SUBDIVISION REVIEW SHEET**CASE NO.:** C8-2019-0065.0A**COMMISSION DATE:** July 25, 2023**SUBDIVISION NAME:** Sankofa Subdivision**ADDRESS:** 2208 E 13th St**APPLICANT:** Larry Yarak & Brenda Blair**AGENT:** Campbell Key (Southwest Engineers, Inc.)**ZONING:** SF-3-NP (single family residence)**NEIGHBORHOOD PLAN:** Chestnut**AREA:** 0.19 acre (8,276.4 sf)**LOTS:** 2**COUNTY:** Travis**DISTRICT:** 1**WATERSHED:** Boggy Creek**JURISDICTION:** Full Purpose**SIDEWALKS:** Sidewalks will be constructed along Chestnut Ave and E 13th St.**DEPARTMENT COMMENTS:**

SANKOFA SUBDIVISION

**CITY OF AUSTIN –DEVELOPMENT SERVICES DEPARTMENT
SUBDIVISION APPLICATION – MASTER COMMENT REPORT**

PROJECT NAME: Sankofa Subdivision
LOCATION: 2208 E 13TH ST

Exhibit B: Proposed plat

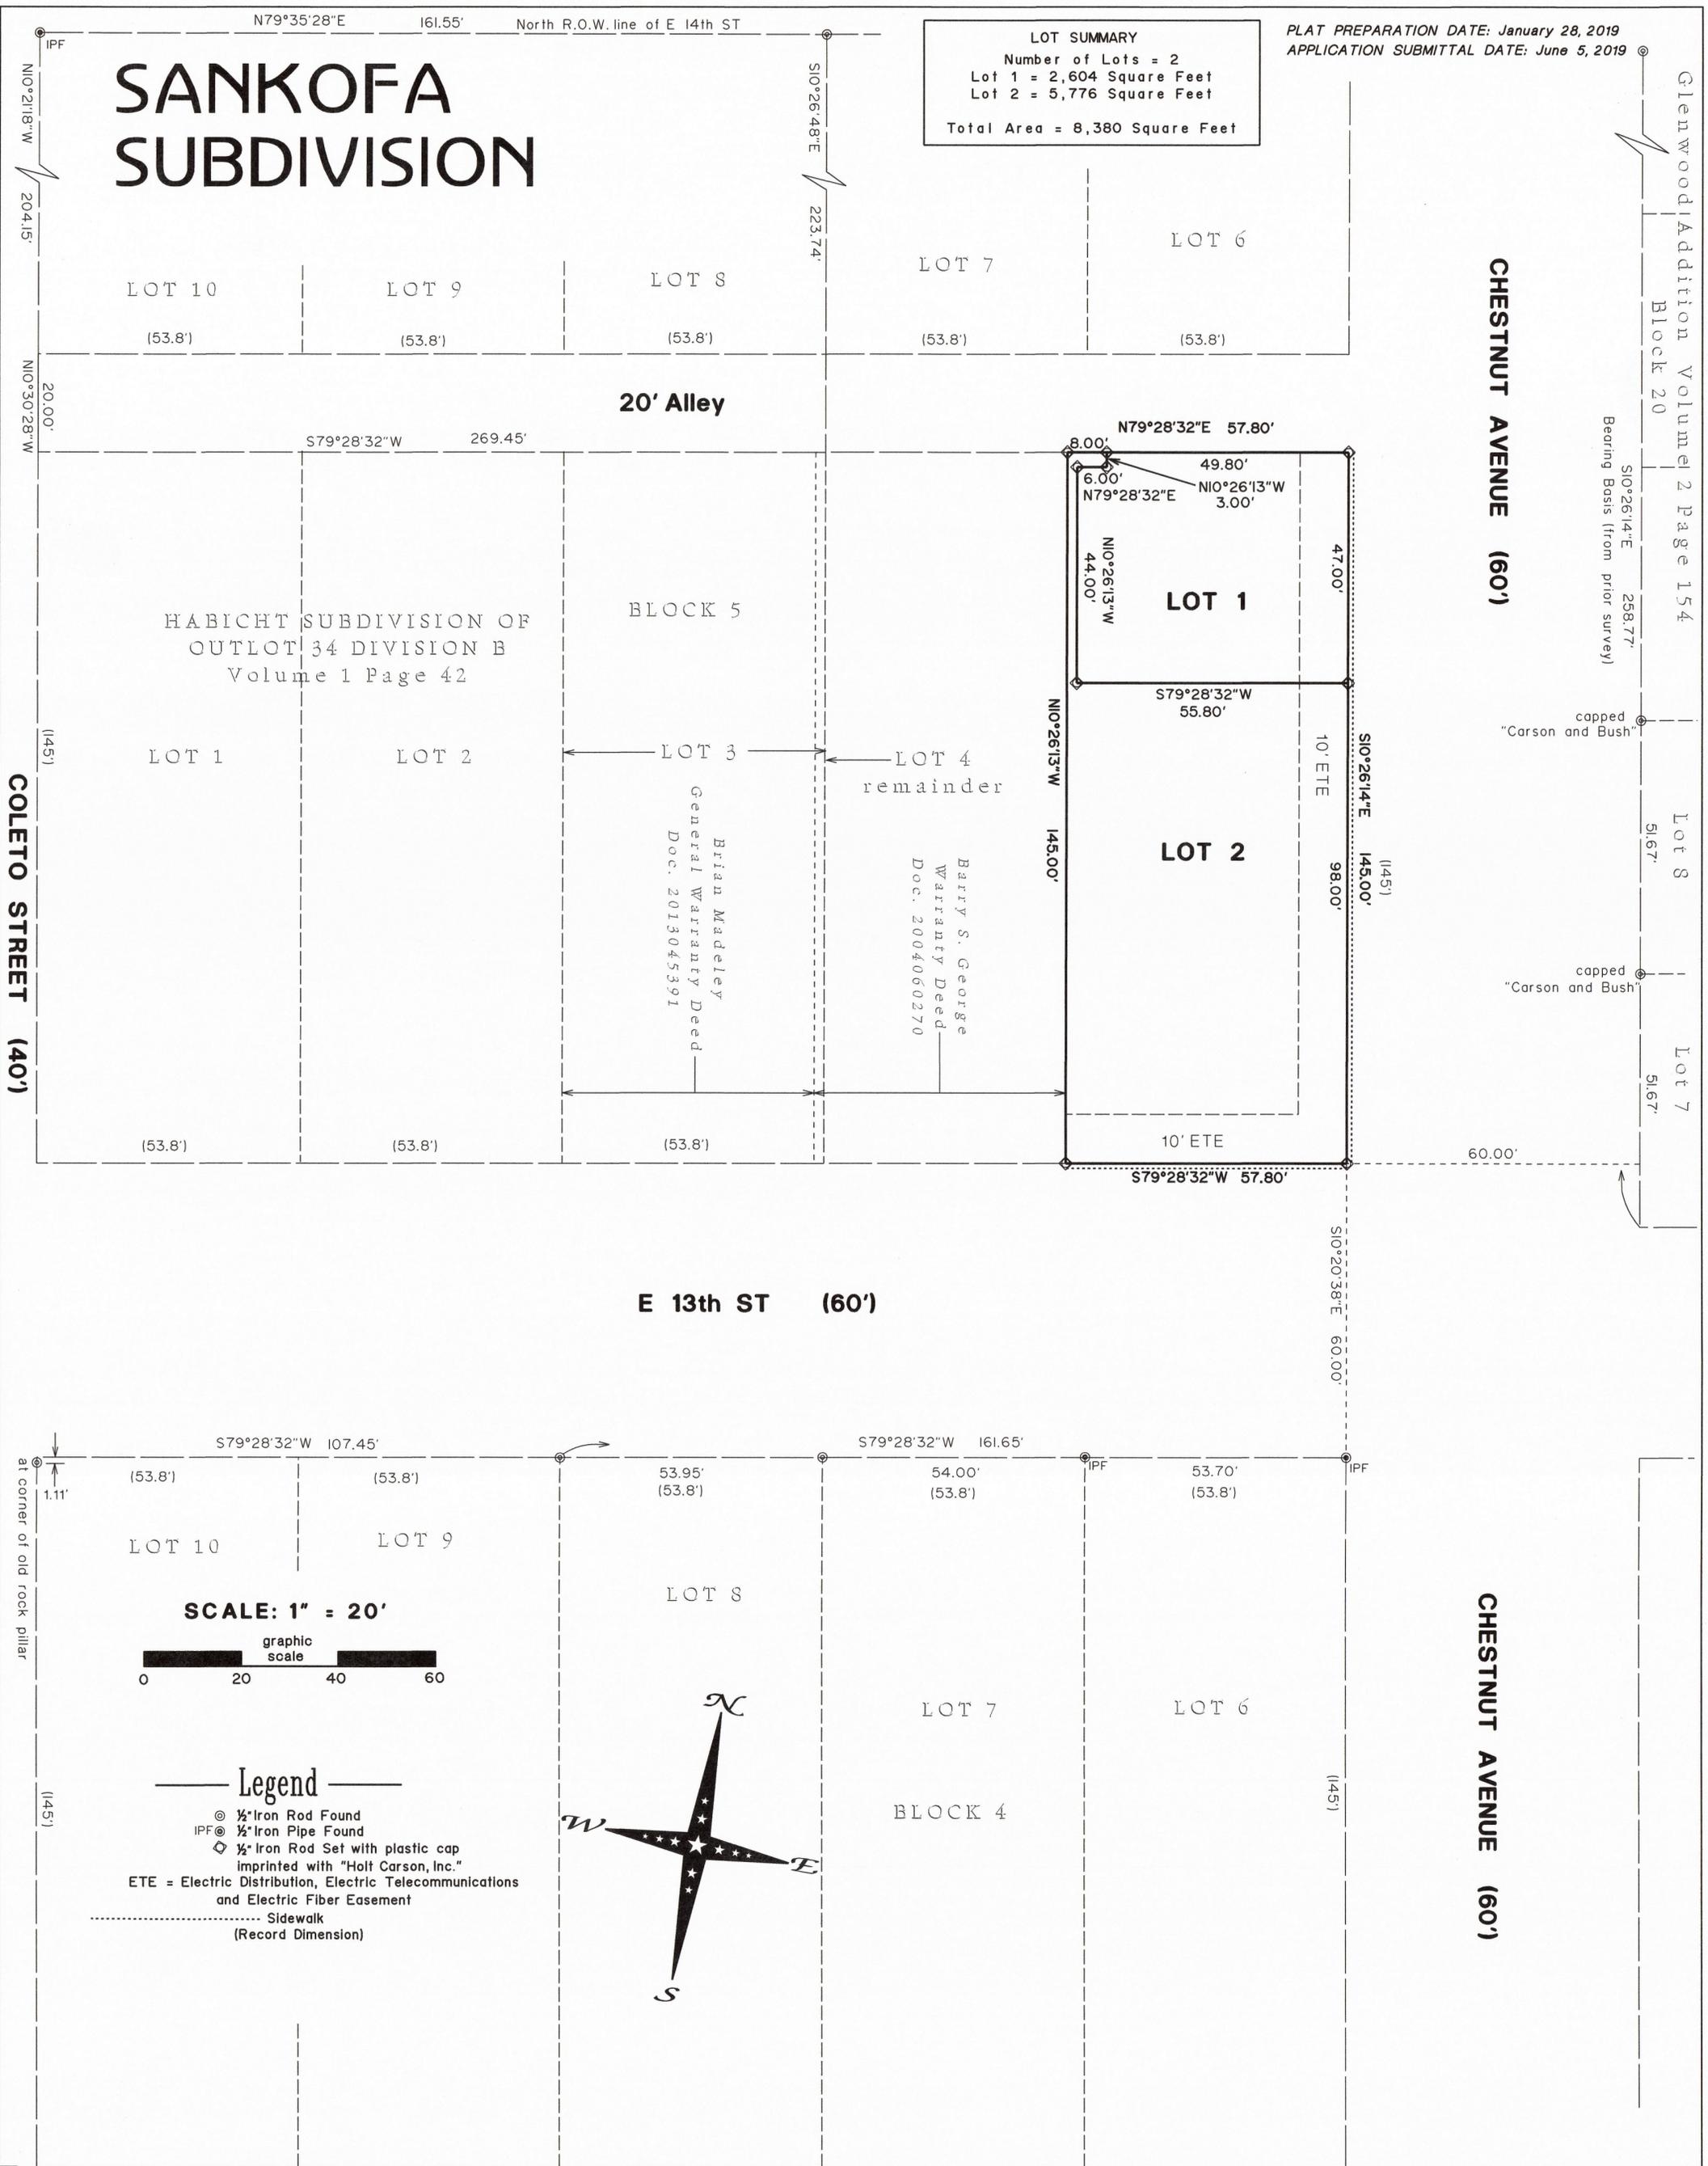
- DE 1. Provide a copy of the previous subdivision: Habicht Subdivision of Outlot 34 Division B.
U1. Comment Cleared.
- DE 2. Please add the following notes: [LDC 25-7-152]

- "Property owner shall provide for access to drainage easements as may be necessary and shall not prohibit access by governmental authorities."
 - "All streets, drainage, sidewalks, erosion controls, and water and wastewater lines are required to be constructed and installed to City of Austin Standards".
U1. Comment Cleared.

- DE 3. Please add the following note:
ON-SITE DETENTION
 "Prior to construction on lots in this subdivision, drainage plans will be submitted to the City of Austin for review. Rainfall run-off shall be held to the amount existing at undeveloped status by ponding or other approved methods. All proposed construction or site alteration on Lot(s) _____ Block(s) _____ requires approval of a separate Development Permit."
U1. Comment Cleared.

- DE 4. Please add the following note:
EXEMPTION FROM DETENTION (G)
 "Development activity for single family or duplex use for Lots _____ and _____ is not subject to Drainage Criteria Manual, 1.2.2.D. or E in accordance with Drainage Criteria Manual Section 1.2.2.G. and Engineer's certification dated _____."
 *Use this note in conjunction with the standard onsite note above
U1. Comment Cleared.

- DE 5. Due to a process change for DCM 1.2.2 G cases, a feasibility meeting will be required. Please request a meeting at RSMP@austintexas.gov and please include this reviewer.
 U1. Comment Pending RSMP approval/payment.
 U2. Comment Pending RSMP approval/payment.
 U3. Comment Pending RSMP approval/payment.
 U4. Comment Pending RSMP approval/payment.
U5. Comment cleared.

- PR1. The parkland dedication and park development fee is required (City Code 25-1-601) and must be paid prior to approval. It appears that the intention is to construct a total of 2 residential units on

the proposed 2 lots. However, no parkland fee will be collected for the existing residence, so the fee for 1 unit is required at this time. Park fee bills will be issued in AMANDA with the next update. Please confirm that the number of units is correct.

U5: Park fees have been issued and invoices emailed to the applicant. Please inform this reviewer when invoices have been paid. Noting that Lot 1 is a cottage lot with only one buildable unit.
